**Seagate Technology**  
10323 West Reno (West Dock)  
Oklahoma City, OK 73127-9705  
P.O. Box 12313  
Oklahoma City, OK 73157-2313

Subject: **Proposal for revision of the timing tables and definitions in SPI-4**

This proposal utilizes the timing budget already accepted into SPI-4 and completes the homework to use the timing budget as the basis for modifying the related timing tables, definitions, and figures.

This proposal includes two alternative methods for timing tables along with explanatory figures to illustrate the basic differences in the alternatives. T10 will need to peruse the alternatives and pick the one or ones they are more comfortable with.

# Fast-160 Simplified timing

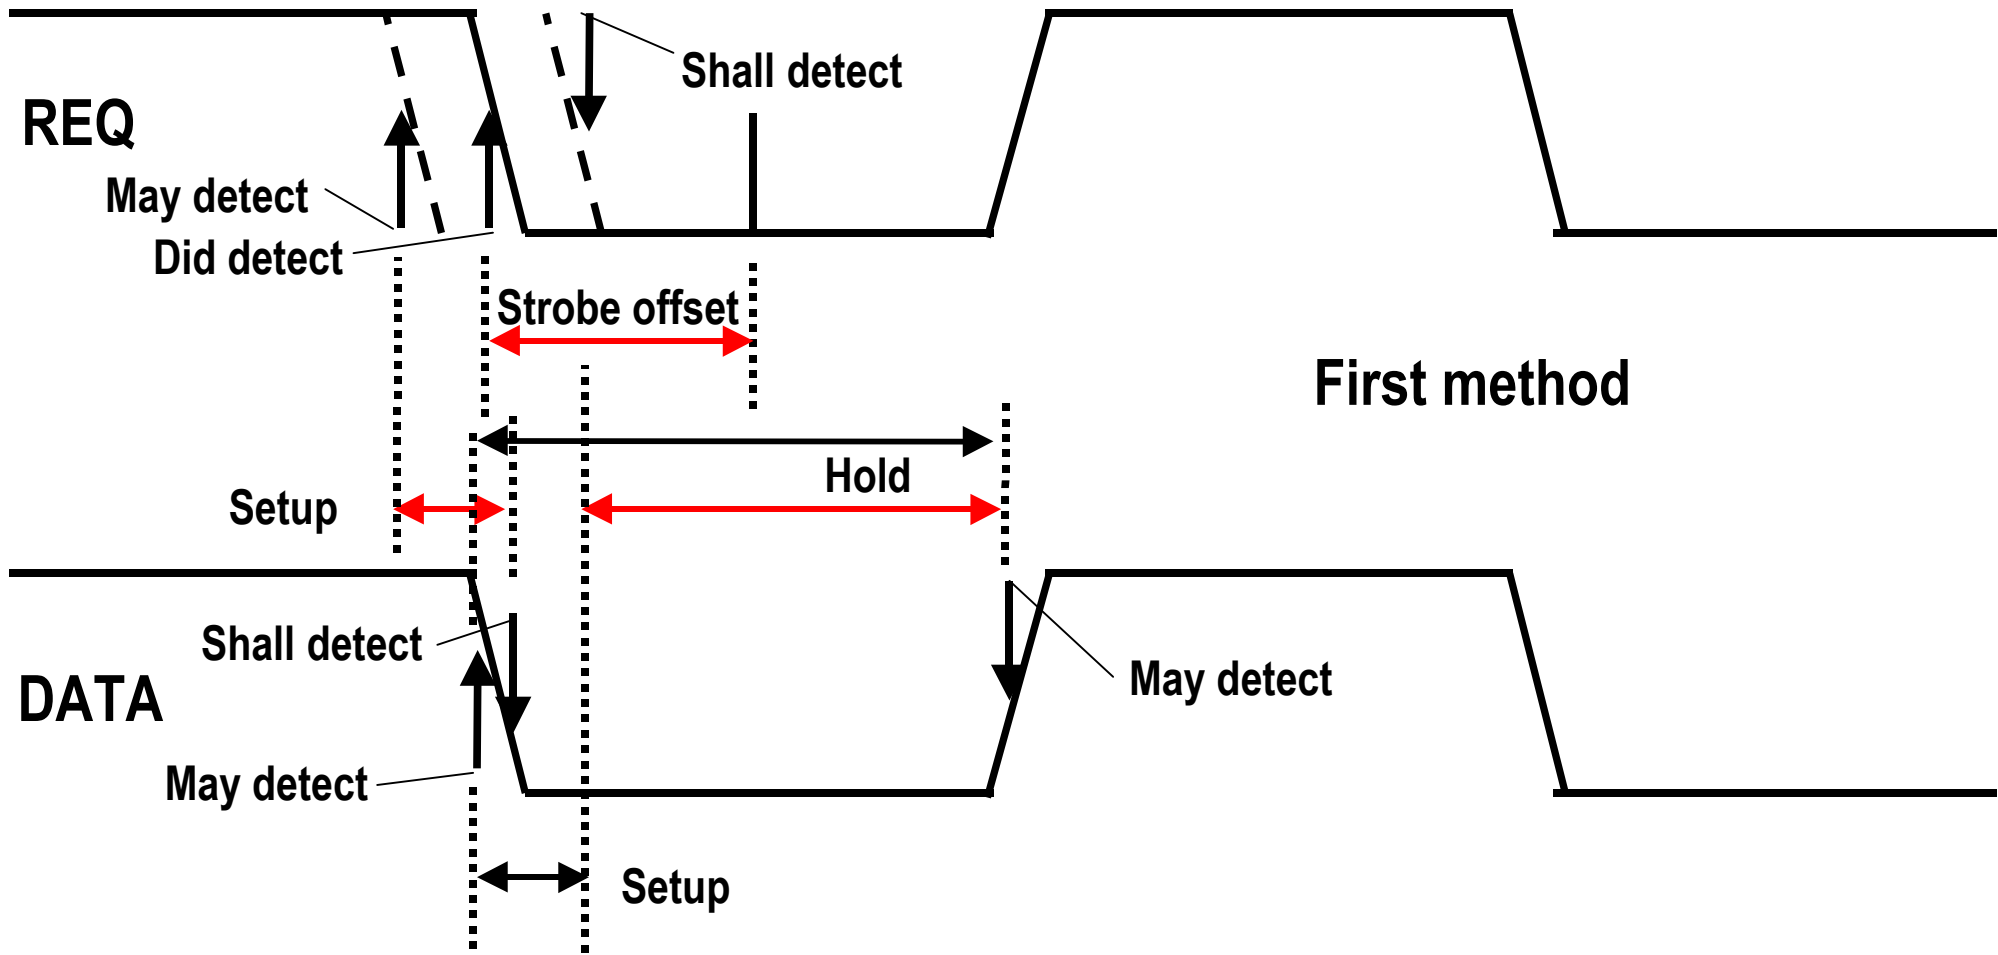
SCSI parallel bus timing values (Table X and Y [formerly 30 & 31] not changed yet but will change or be deleted)

**(First Method is with timing specifications as measured at the SCSI bus connector.)**

Table 28 - SCSI bus data &amp; information phase DT timing values

# Fast-160 Simplified timing

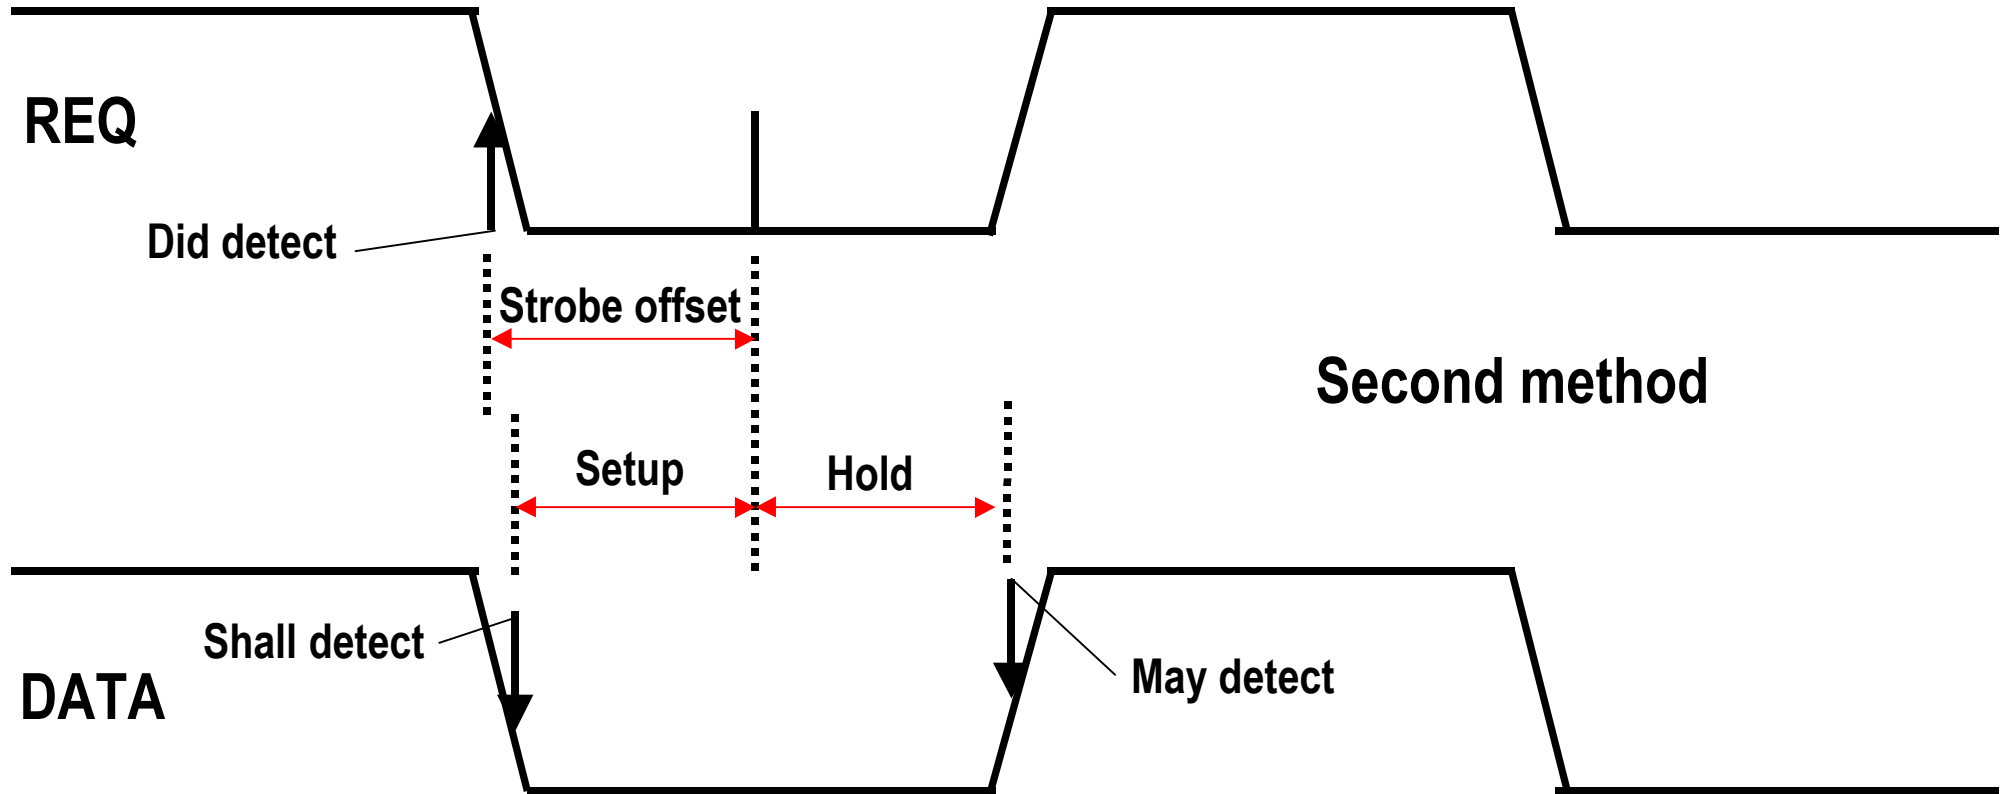
**Potential new table SCSI bus data & information phase DT timing values (Fast-160 Second Method is with setup and hold timing specifications as if after deskewing and strobe offset.)**

Table 29: SCSI bus data &amp; information phase DT timing values (Fast-160 Second Method)
